# PROCESS TECHNOLOGY BUILDING EXPANSION for SOWELA Technical Community College

SOWELA Technical Community College Foundation Project No. 2026-01  
CEH Project No. 2506

## ADDENDUM NO. 1

Issue Date: Tuesday, May 19, 2026

ADD.1-1

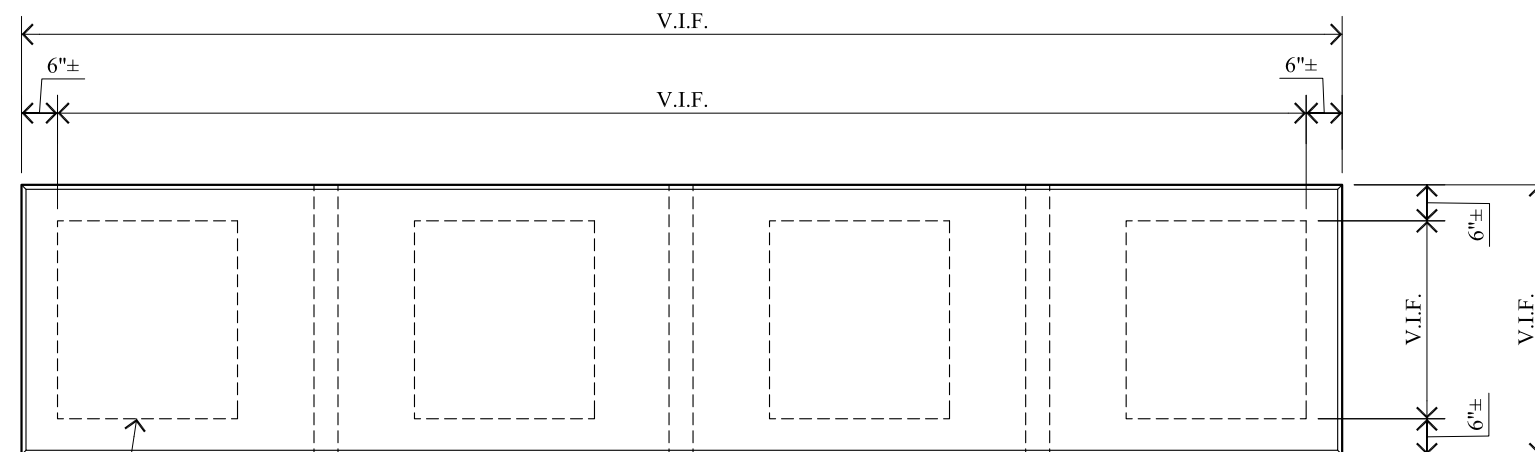
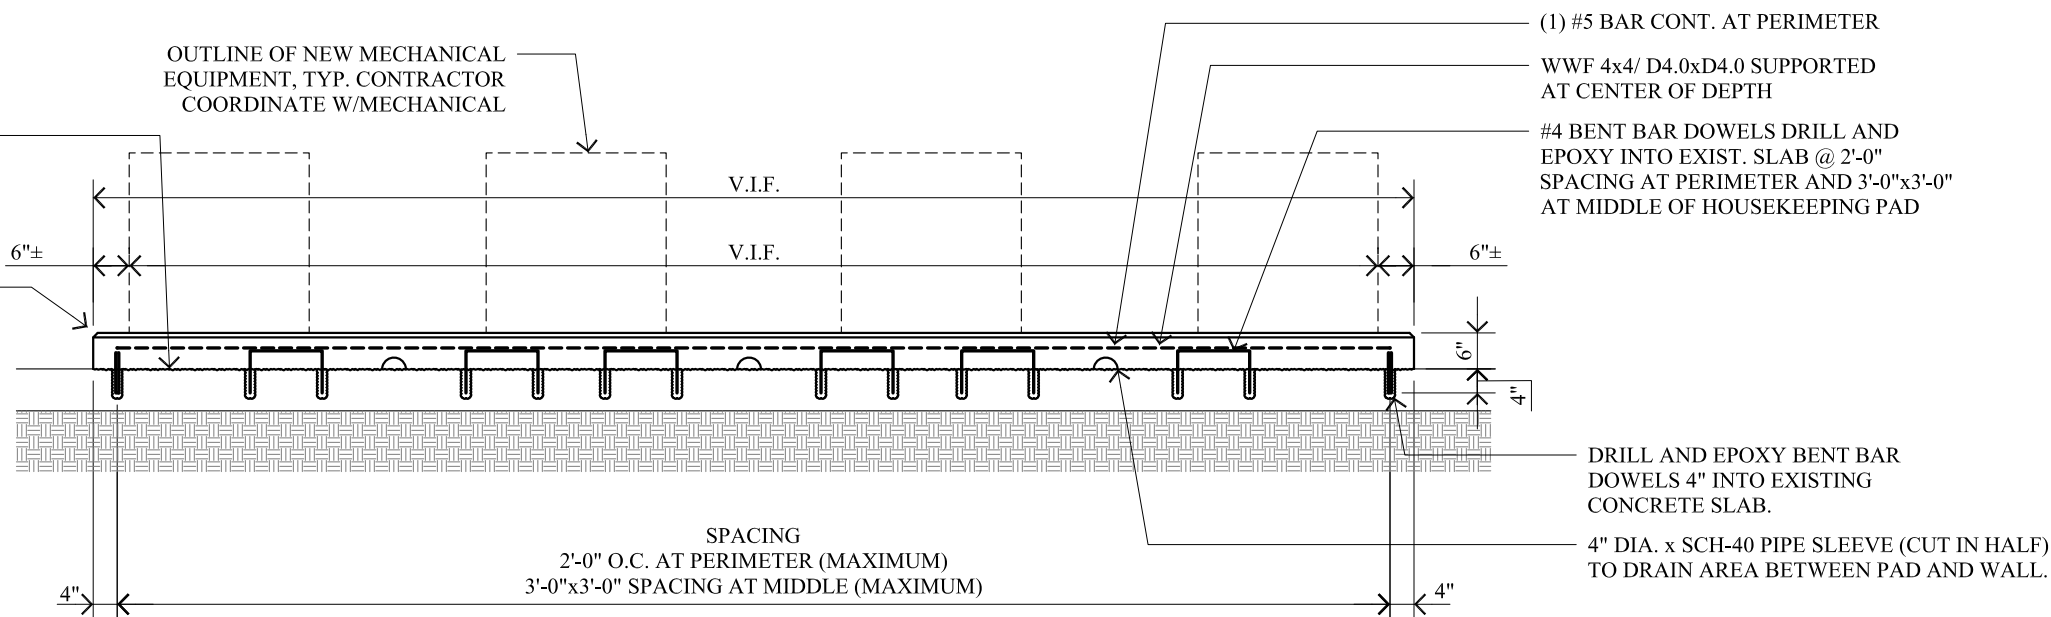
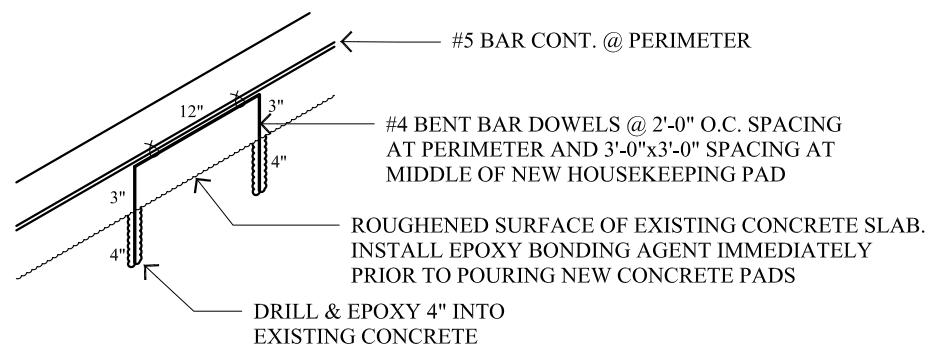
26. Reference Revised Mechanical Drawings (to be included in Addendum No.2) and Drawing ADD.1-1, included with this addendum, with revised placement of CU-6A, CU-6B, CU-7, and CU-8. Provide a new concrete housekeeping pad on top of the new concrete area paving. Housekeeping pad shall continuous below all (4) condensing units, and shall extend 6" larger than the dimension of the largest condensing unit at each side. Top of pad shall be level, set 6" high at the high side of the area paving.

27. Reference Drawing A2.1 "New Architectural Floor Plan" and Detail 2/A4.1 "New West Exterior Elevation". Offset the bottom of (2) downspouts located behind mechanical pad to align with drain sleeves in Mechanical Equipment Housekeeping Pad.

**A1.2B**  
ISSUE DATE:  
5 / 19 / 2026

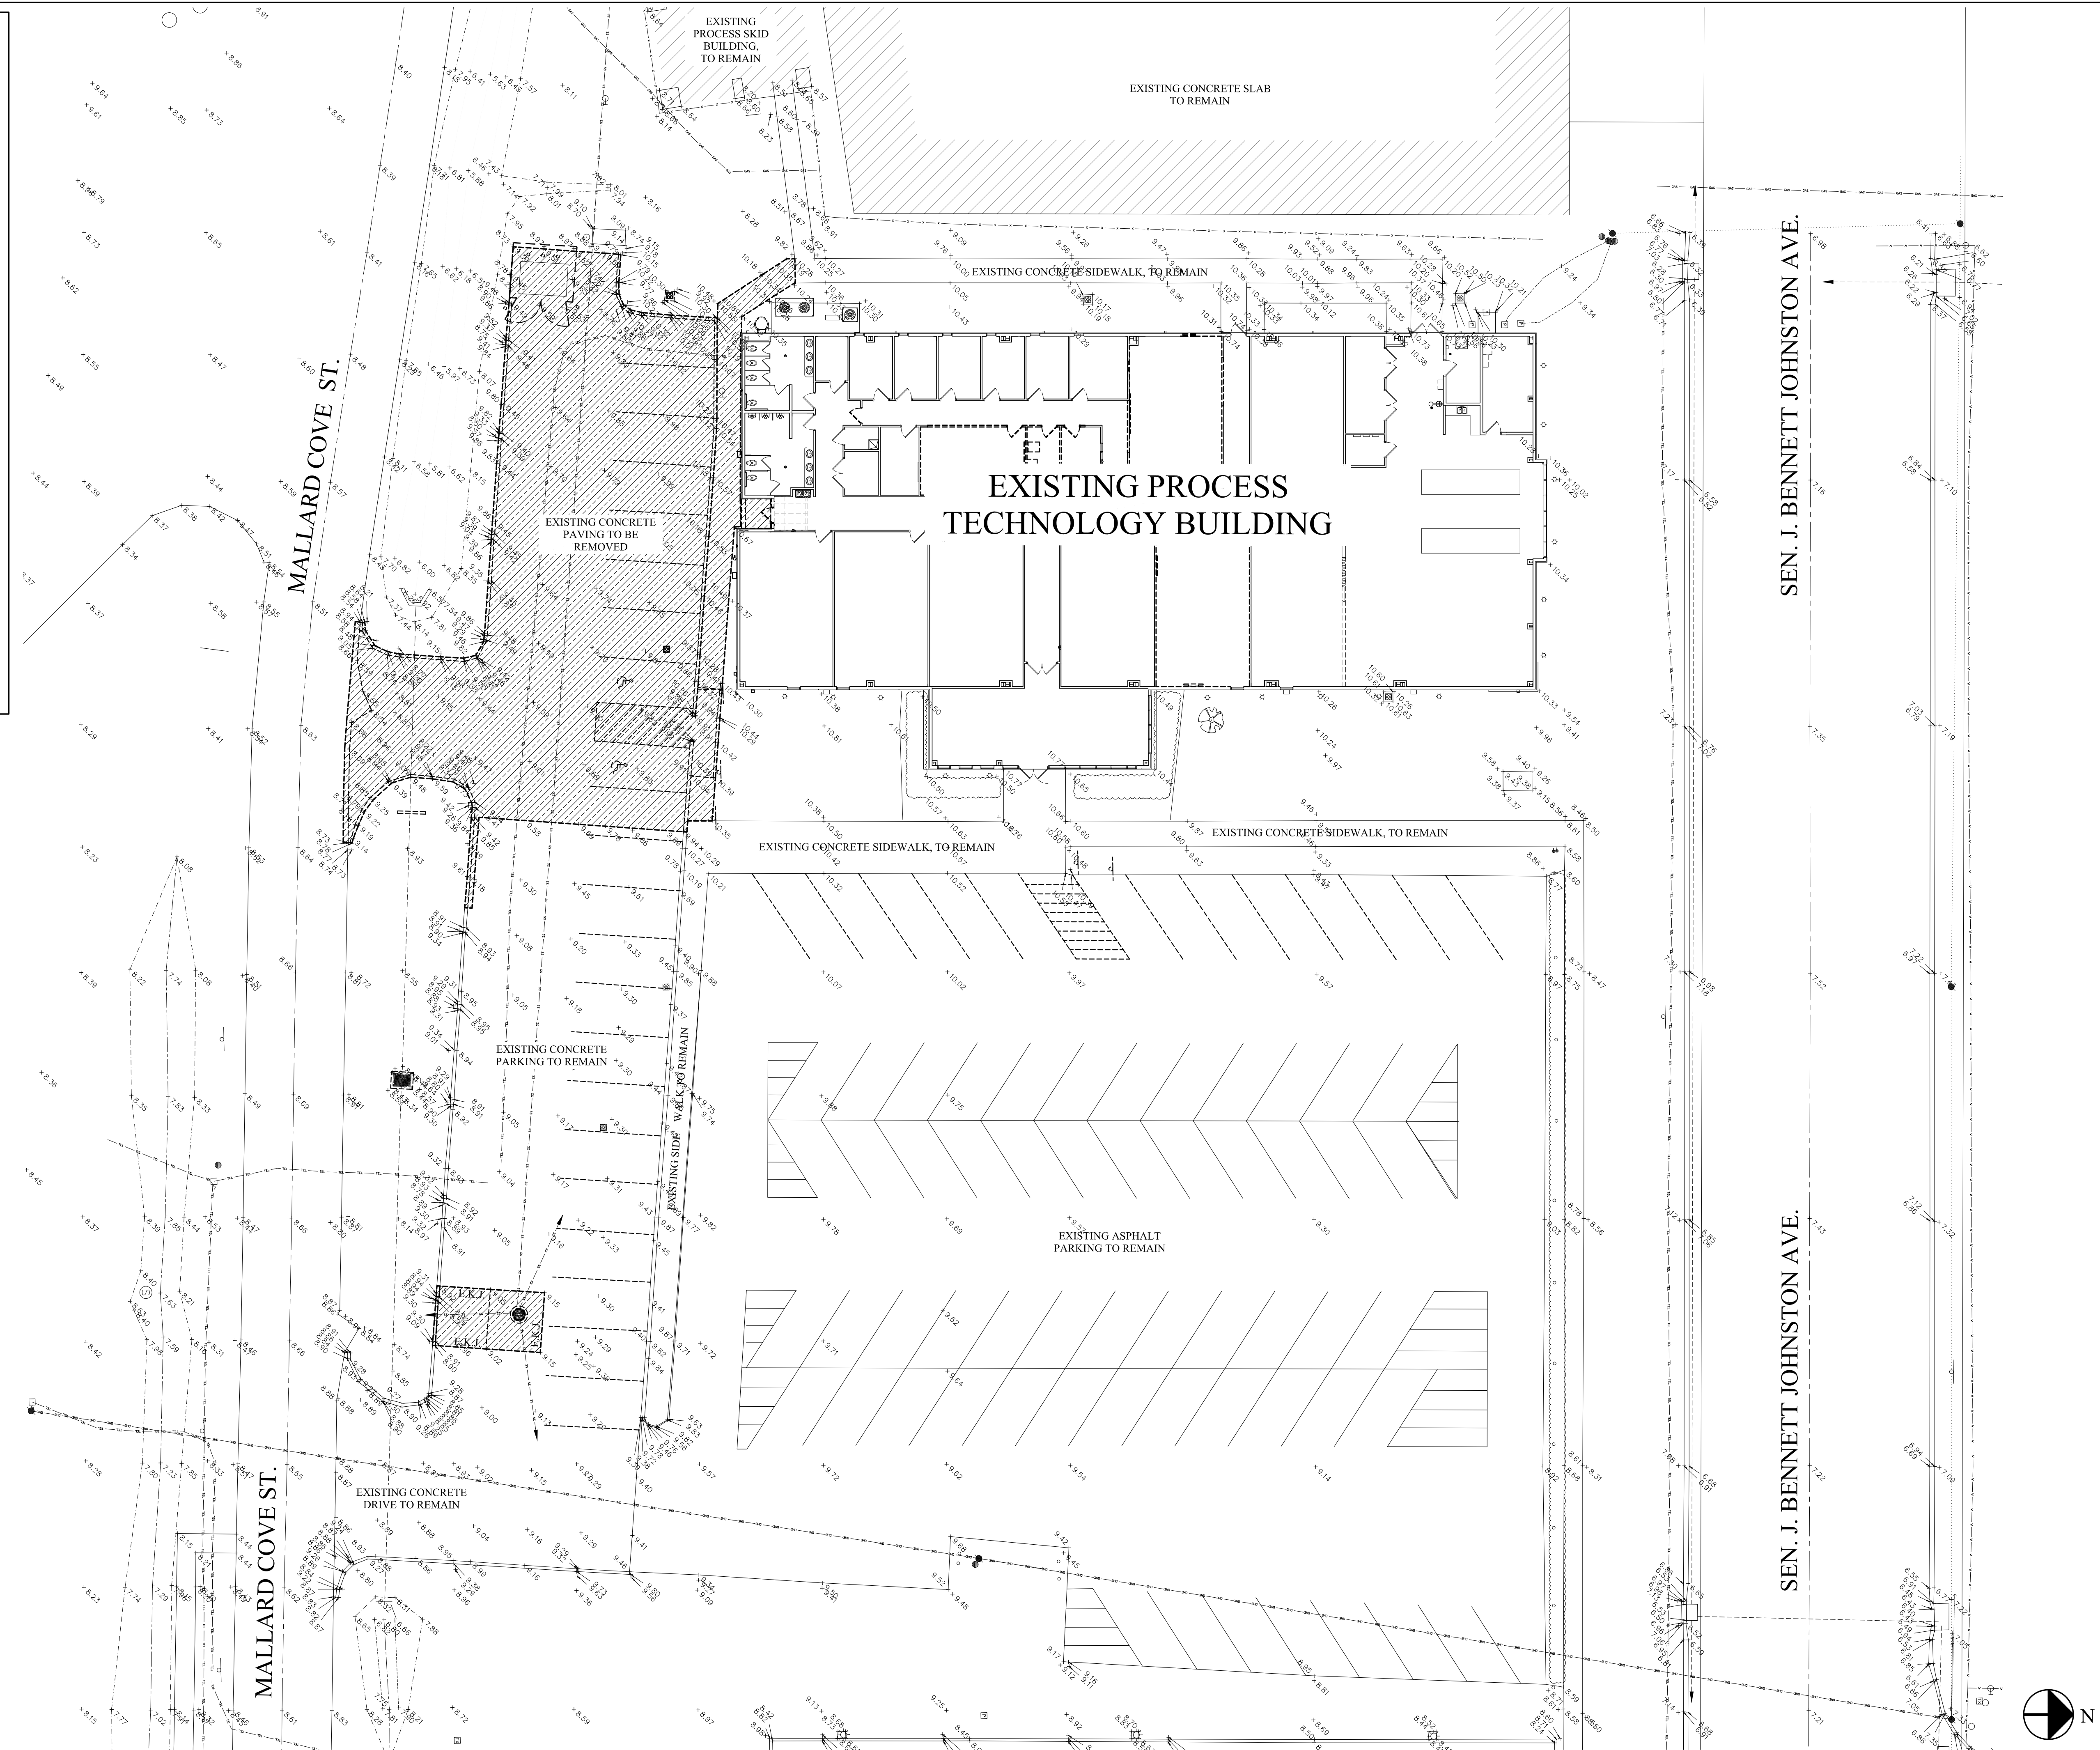
1. Drawing ADD.1-1 "New Mechanical Equipment Housekeeping Pad Detail", dated 5.19.2026, 1 sheet @ 17"x11" size.
2. Drawing A1.2B "Existing / Demolition Site Plan (Existing Grade Elevations)", dated 5.19.2026, 1 sheet @ 36"x 24" size
